DEVIATION REQUEST AND DECISION FORM

Project Name : Village at Lorson Ranch Filing 1
Schedule No.(s) : 5515413054
Legal Description : See Attached

A deviation from the standards of or in Section 2.5.2.F.2 of the Engineering Criteria Manual (ECM) is requested.

TRAFFIC EXHIBIT
PROPOSED ALTERNATIVE

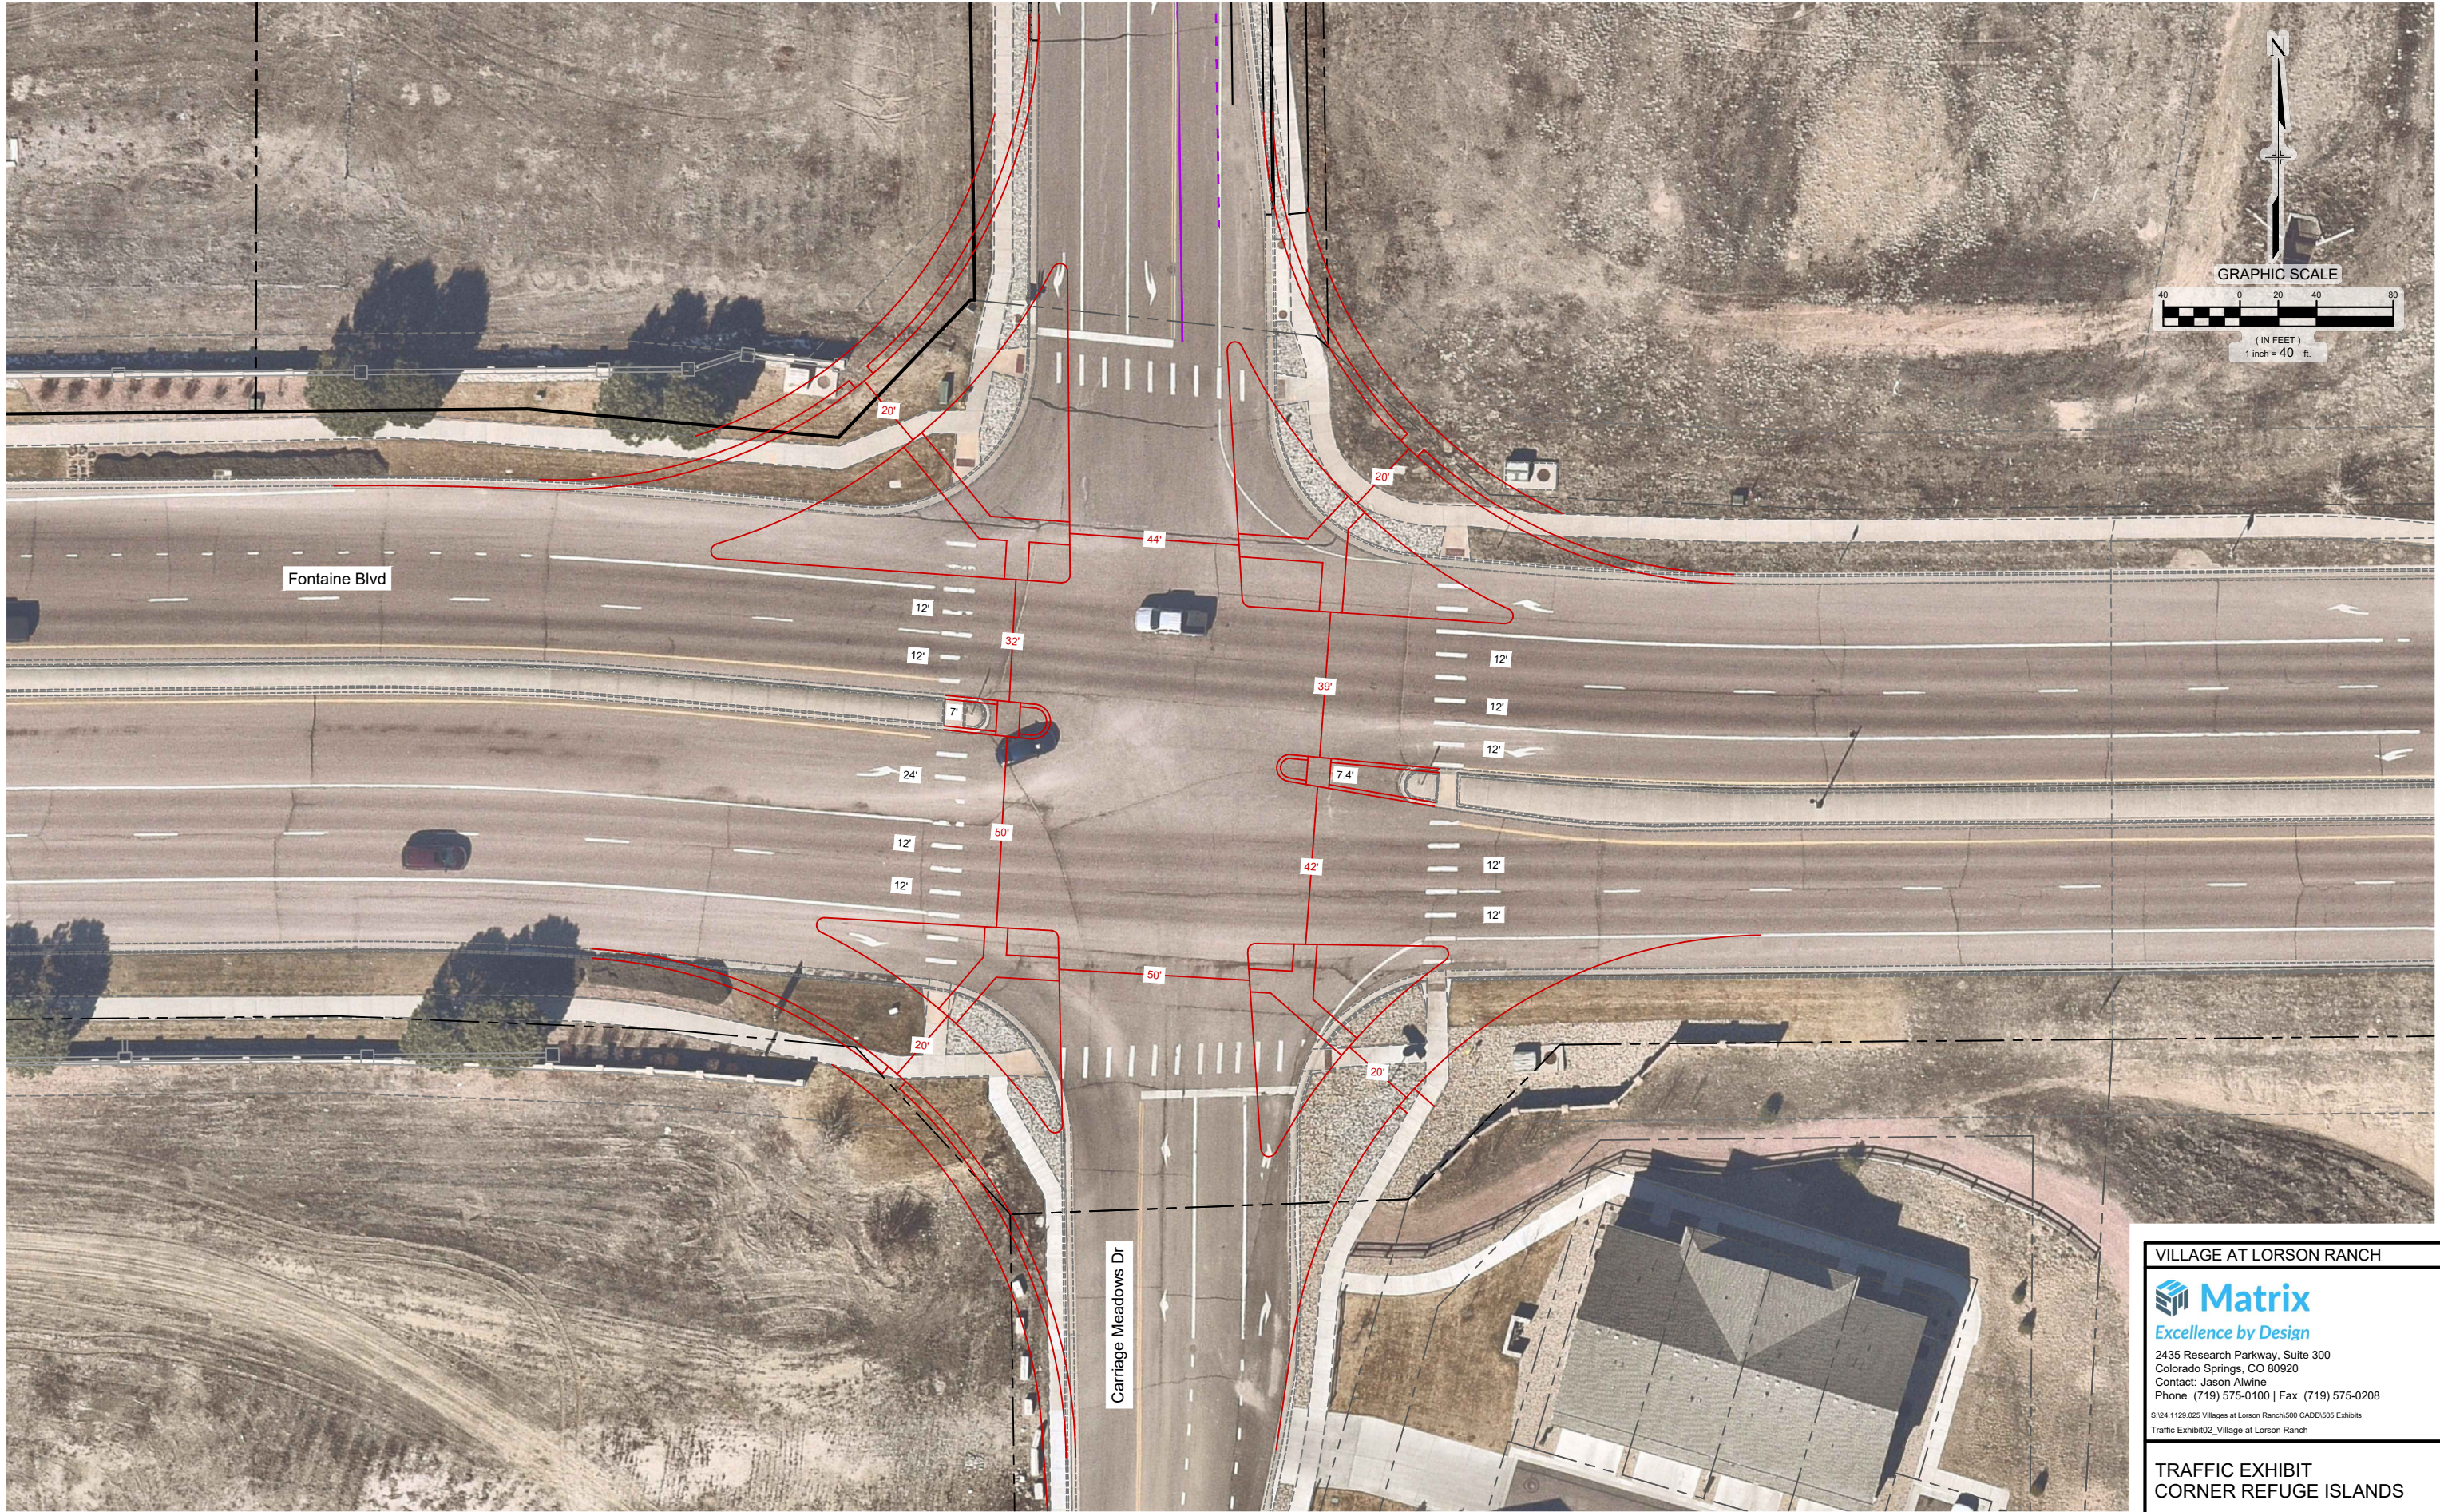
EPC will not accept this additional length

Please provide backup for the required radius to accommodate the WB - 67 design vehicle
